Staff Report

RE: Level 2 Unified Permit Amendment– BMS Cell Therapy Facility Interim Parking and Loading Dock Modifications

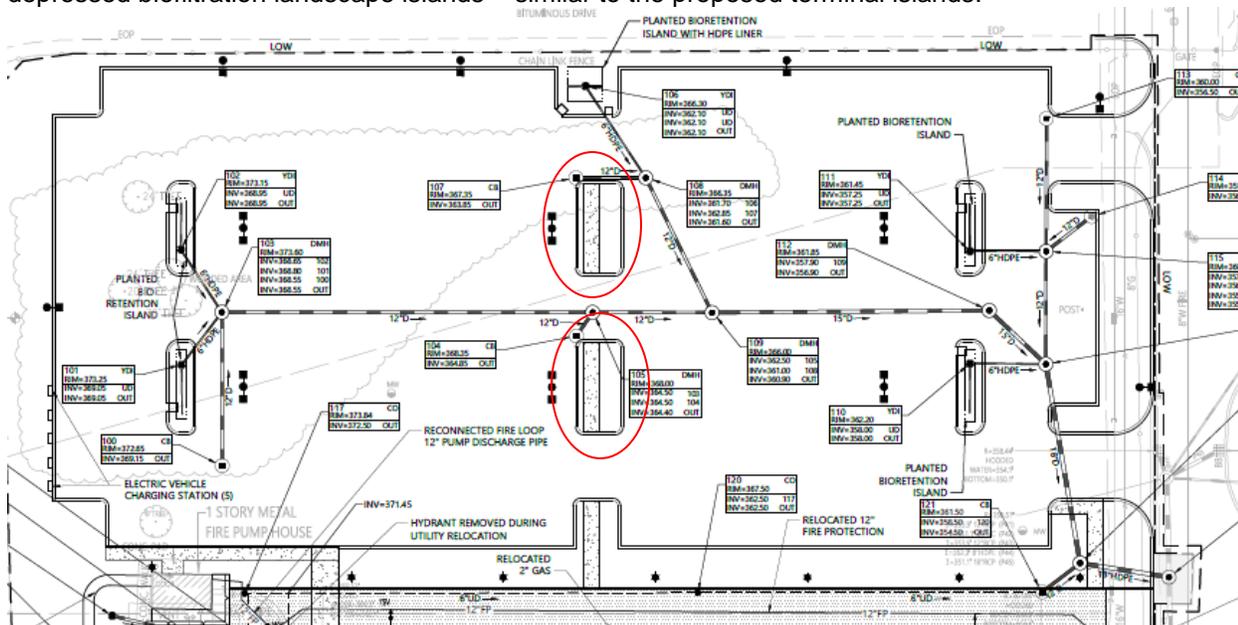
Regarding the third item, Staff has discussed this with the Applicant's engineer and they have agreed to modify the two central/intermediate landscape islands in the northern-most parking lot from raised islands to depressed biofiltration landscape islands – similar to the proposed terminal islands:

Biofiltration landscape islands in these locations would be consistent with 974 CMR 3.04(3)(a)1.e. which requires landscape islands to serve a functional purpose for stormwater infiltration and evapotranspiration. We reviewed this with our peer review engineers and they agreed that this design modification could be addressed as a condition of approval.

Heavy Duty Flexible Pavement

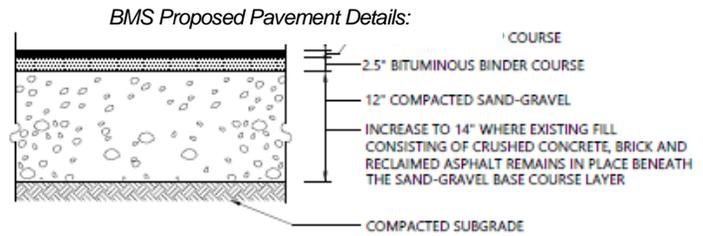
Proposed pavement thickness: Regular pavement and heavy-duty pavement details on 100-10C-600.2 do not comply with 974 CMR 3.04(3)(a)2.a. and b. which require Heavy Duty pavement to have 12" of compacted gravel base, 3" of bituminous base course, 1½" of bituminous binder course, and 1½" of bituminous concrete top course. The Applicant's proposed Heavy Duty Pavement is actually slightly thicker. The DEC's regular pavement detail requires 12" of compacted gravel sub-base, 2" of bituminous binder course and 1½" of bituminous top course. This is a minor difference in the compacted subgrade material (2" less). Section 3.04 (3)(a)(2)(c) of the DEC regulations states that the Applicant may pose modifications to the pavement construction where anticipated traffic and usage justify a lesser standard. The pavement structure proposed is consistent with the rest of the BMS campus, which was based on the recommendations of the original Geotechnical Engineers and previously approved by the DEC. To address this, the DEC should make a finding that the proposed regular and heavy-duty pavement details are sufficient based on previously submitted geotechnical investigations.

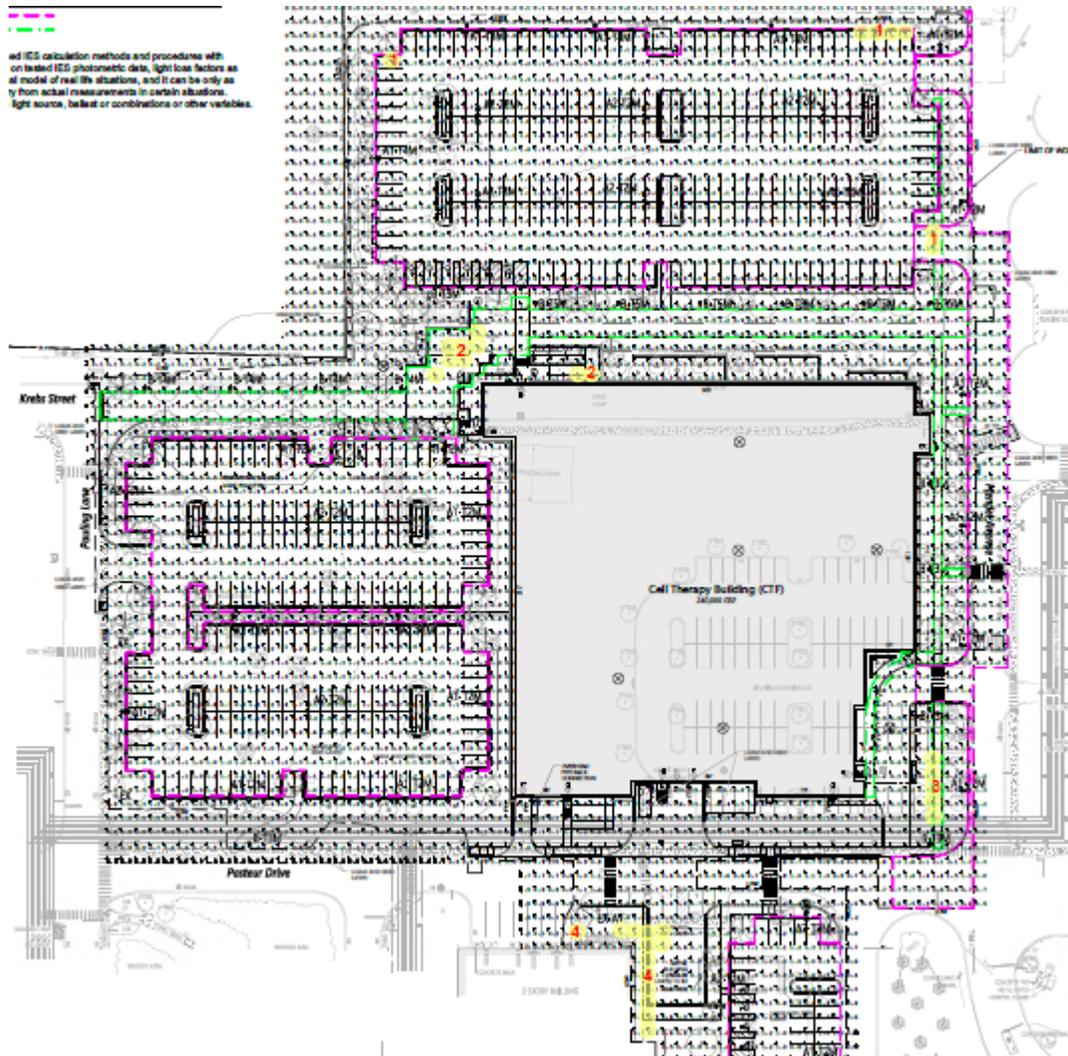
Minor areas around the perimeter of the new parking and walkway areas do not meet this requirement (yellow highlighted areas in the diagram on the next page) however the Applicant has modified the lighting layout to address some of these deficiencies and all critical areas like walkways and drive aisles still have some level of lighting for safety. The photometric plan does not take into account some of the building-mounted lighting as well.

This waiver is consistent with previous approvals for this site and will further aid in reducing light pollution within the Viewshed Overlay District. Staff has no concern with this waiver request.
